Still Water Phases 5 and 6 Final Plats 2000 West Parkview Drive

#### **Still Water Subdivision Phase 5**

#### Still Water Subdivision Phase 6

# STILL WATER PHASE 5

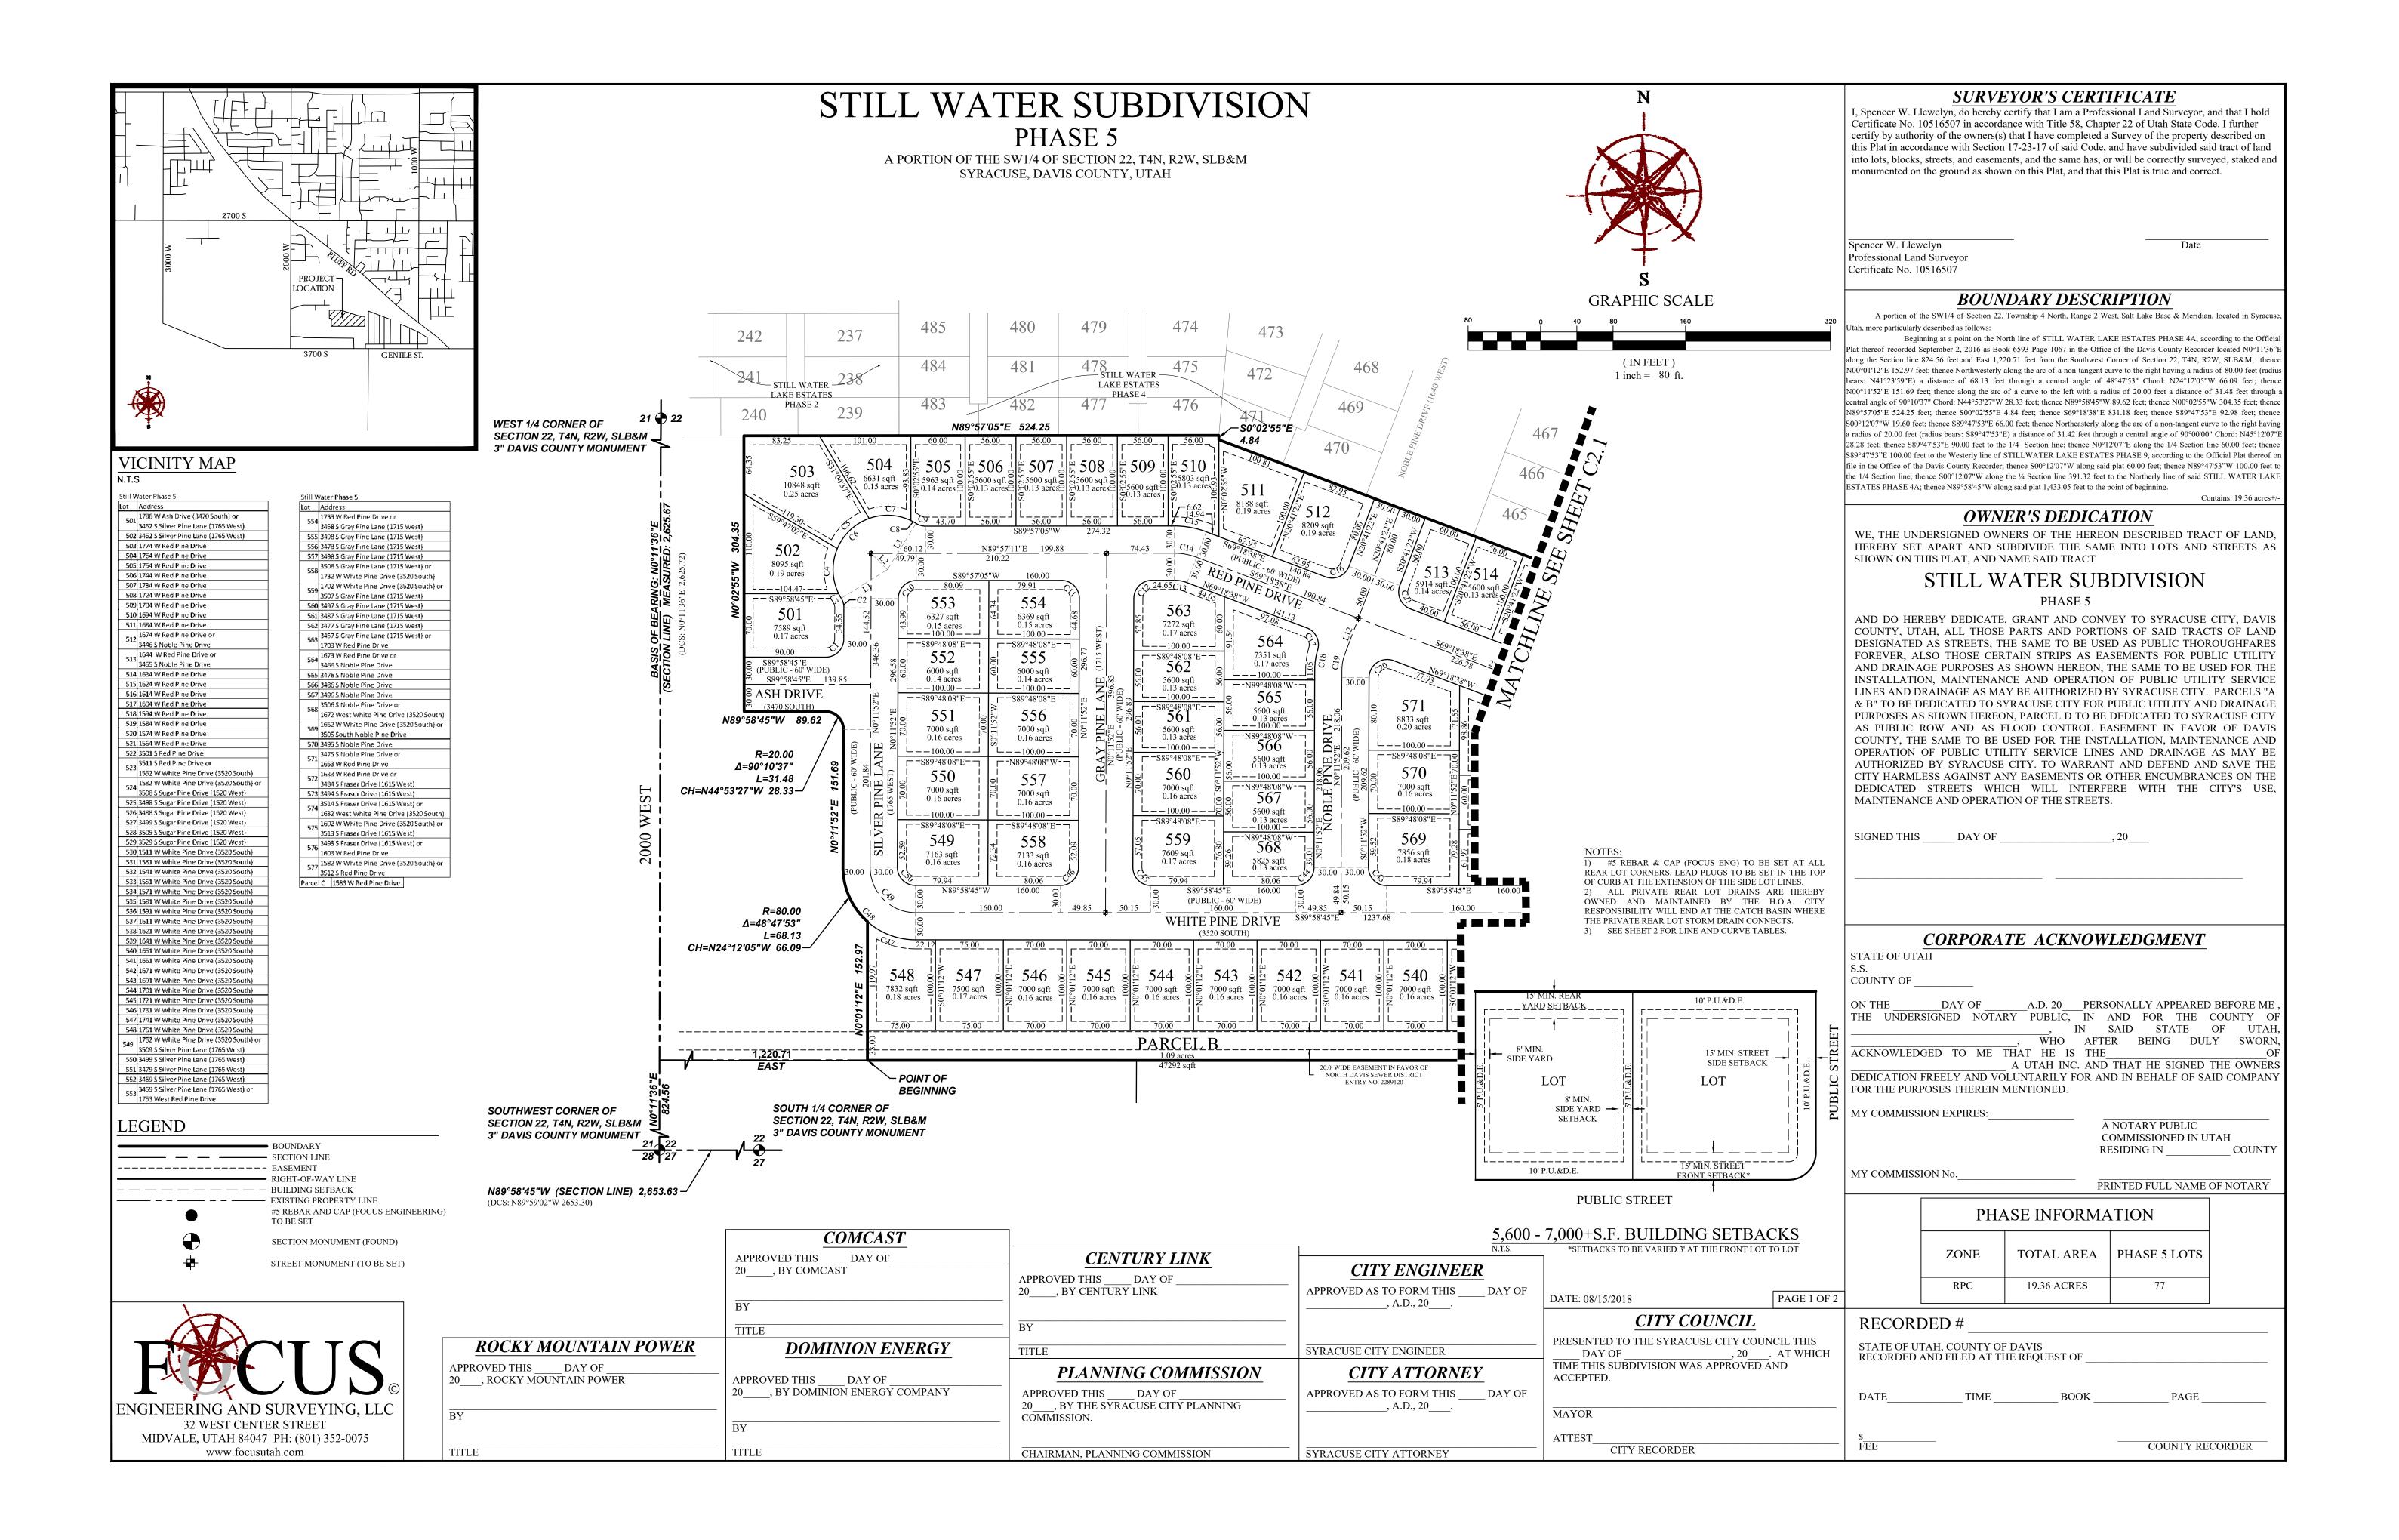
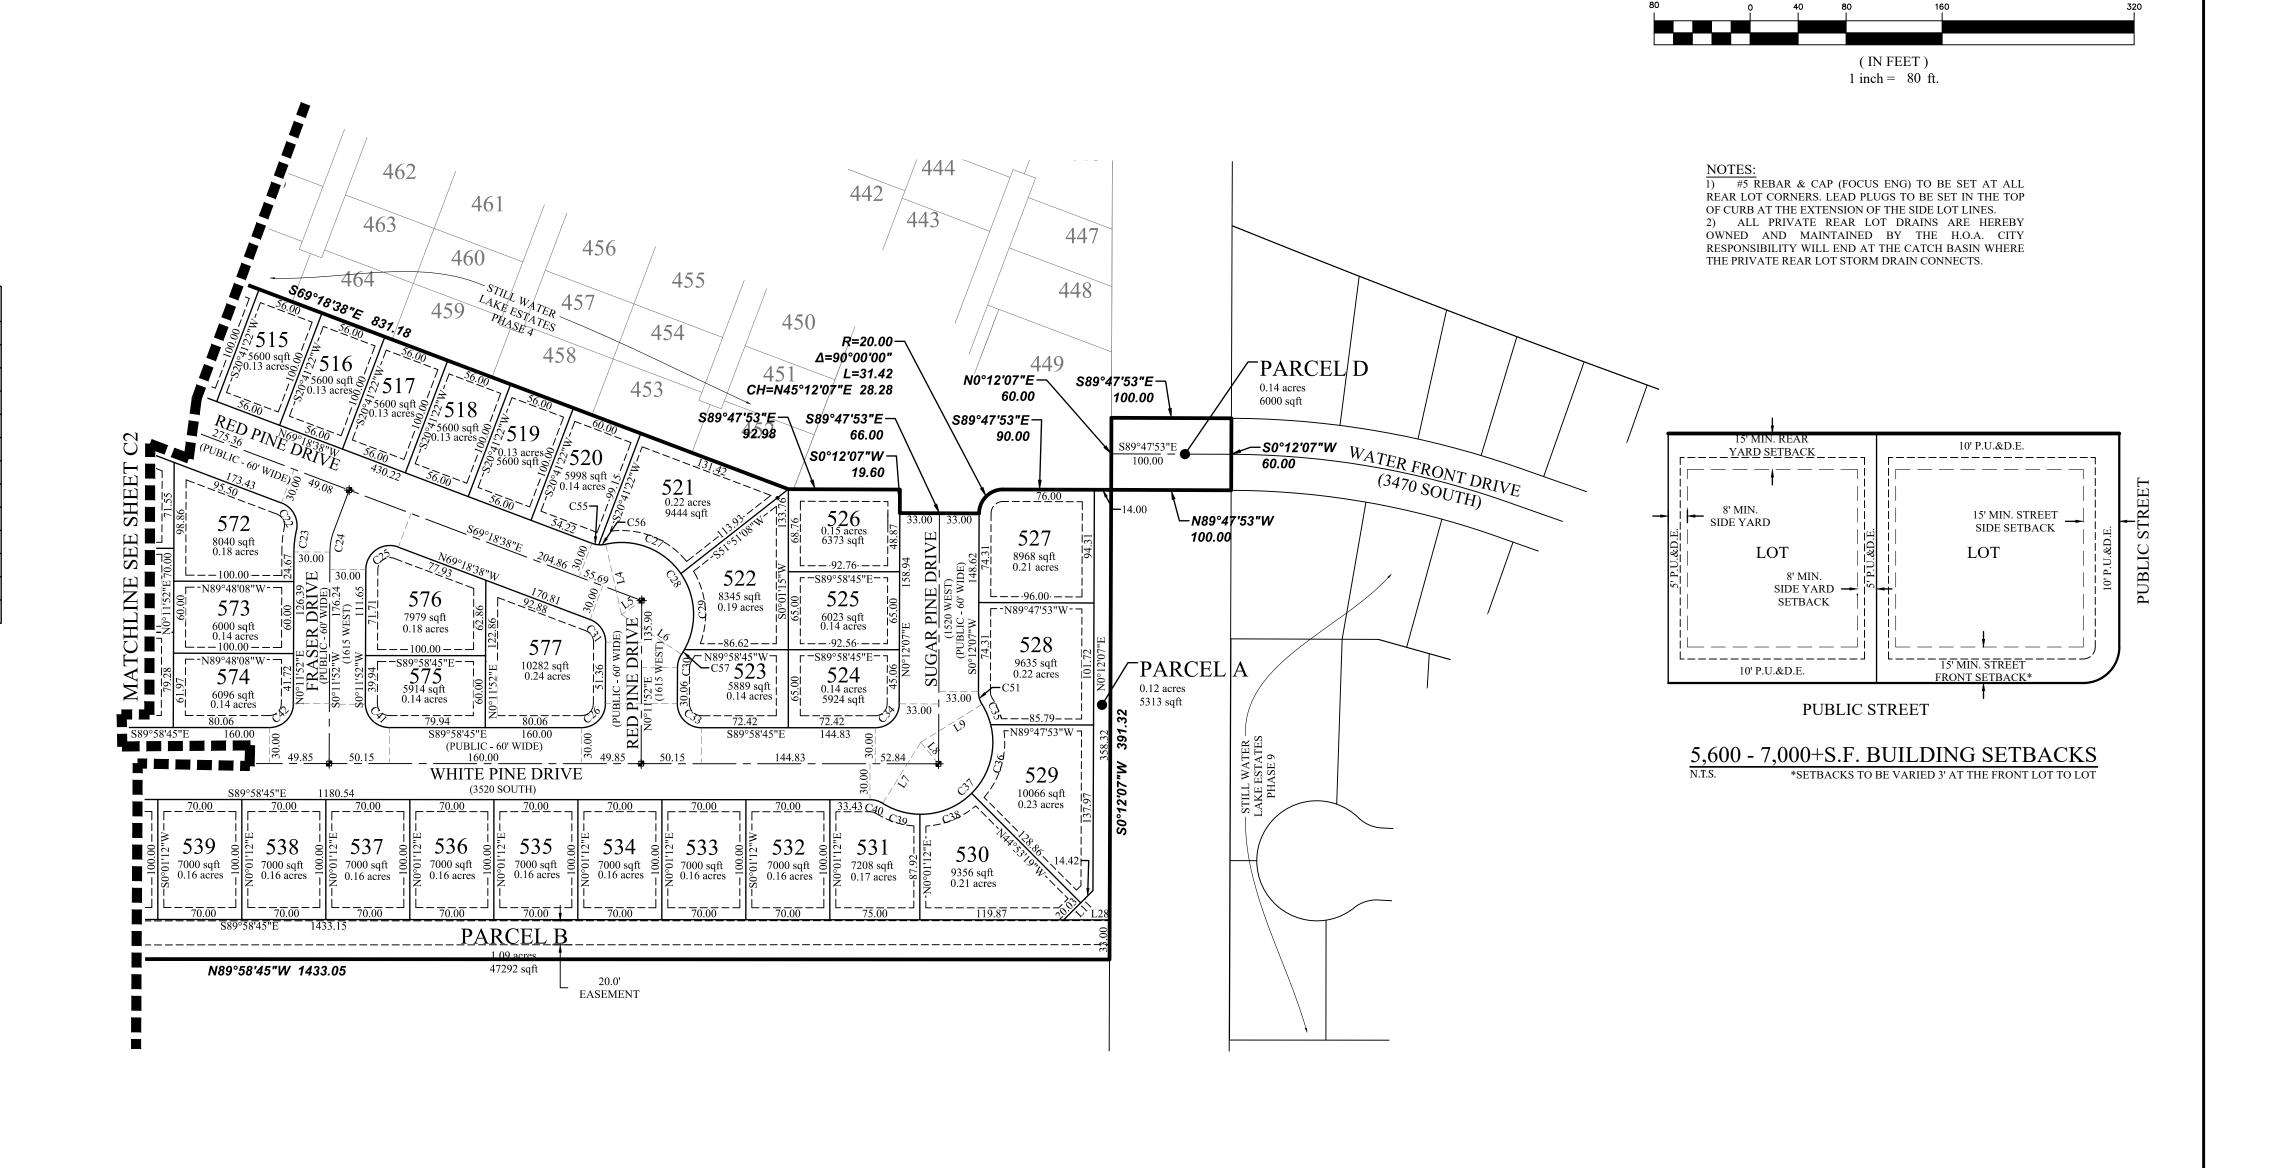
- 1. Secondary services are needed for parcel A & B.
- 2. Add a 6" secondary drain into SDMH#503.
